World Forum for Harmonization of Vehicle Regulations**Working Party on Lighting and Light-Signalling****Seventy-first session**

Other Business – Any other business**Proposal for Supplement 17 to Regulation No. 50 (Motorcycle Lamp Components)****Submitted by the expert from the International Motorcycle Manufacturers Association***

The text reproduced below was prepared by the expert from the International Motorcycle Manufacturers Association (IMMA), introducing the possibility of interdependent lamps for dedicated motorcycle lamps. The proposal reflects recent amendments of Regulations Nos. 6 and 7, as well as matching the visibility angle requirements of Regulations Nos. 50 and 53. The modifications to the existing text of the Regulation are marked in bold for new or strikethrough for deleted characters.

- "1. Front position lamps

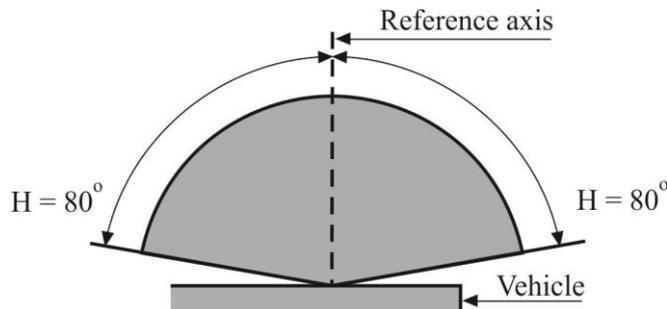
Paragraph 1., amend to read:

$$V = +15^\circ / -10^\circ$$

However, in the case where a device is intended to be installed with its H plane at a mounting height less than 750 mm above the ground, the angle of 10° below the horizontal may be reduced to 5°.

- "2. Rear position lamps

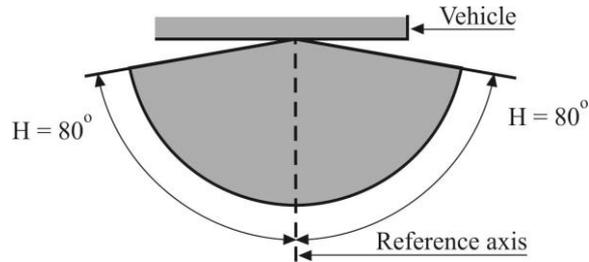
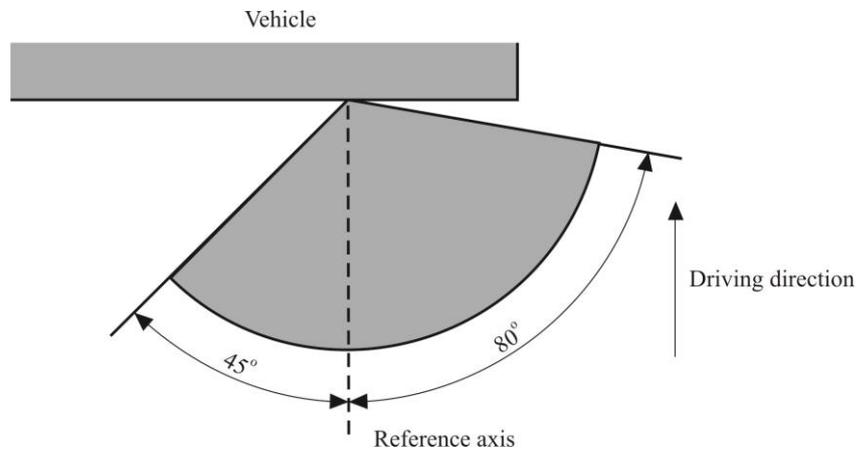
Paragraph 2., amend to read:

$$V = +15^\circ / -10^\circ$$

However, in the case where a device is intended to be installed with its H plane at a mounting height less than 750 mm above the ground, the angle of 10° below the horizontal may be reduced to 5°.

Rear position lamps (for a pair of lamps)

$$V = +15^\circ / -10^\circ$$

However, in the case where a device is intended to be installed with its H plane at a mounting height less than 750 mm above the ground, the angle of 10° below the horizontal may be reduced to 5°.

However, in the case where a device is intended to be installed with its H plane at a mounting height less than 750 mm above the ground, the inward angle of 45° may be reduced to 20° under the H plane."

"3. Direction indicators of categories 11, 11a, 11b, 11c and 12

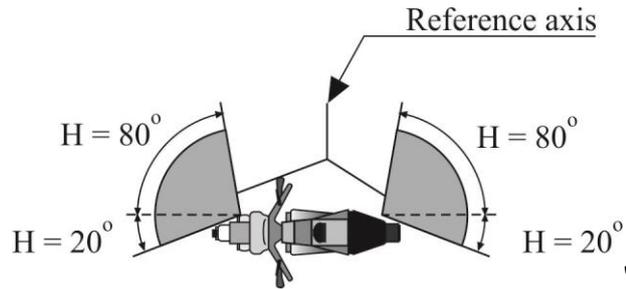
Paragraph 3., amend to read:

$$V = \pm 15^\circ$$

However, in the case where a device is intended to be installed with its H plane at a mounting height less than 750 mm above the ground, the angle of 15° below the horizontal may be reduced to 5°.

Category 11c:

for use at a distance less than 20 mm from the passing beam headlamp.

"4. Stop lamps
 $V = +15^\circ/-10^\circ$

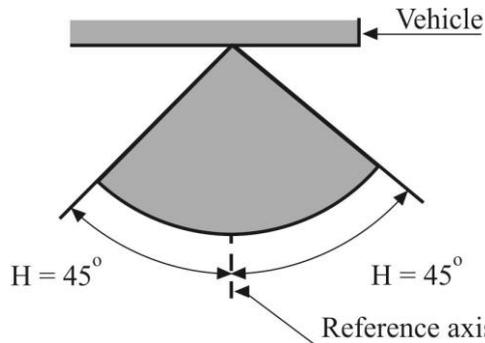
Paragraph 4., amend to read:

However, in the case where a device is intended to be installed with its H plane at a mounting height less than 750 mm above the ground, the angle of 15° below the horizontal may be reduced to 5° .

However, in the case of a pair of lamps, the inboard geometric visibility requirement is deemed to be satisfied if the lamps conform to the photometric values prescribed in the field of light distribution for the approval of the device.
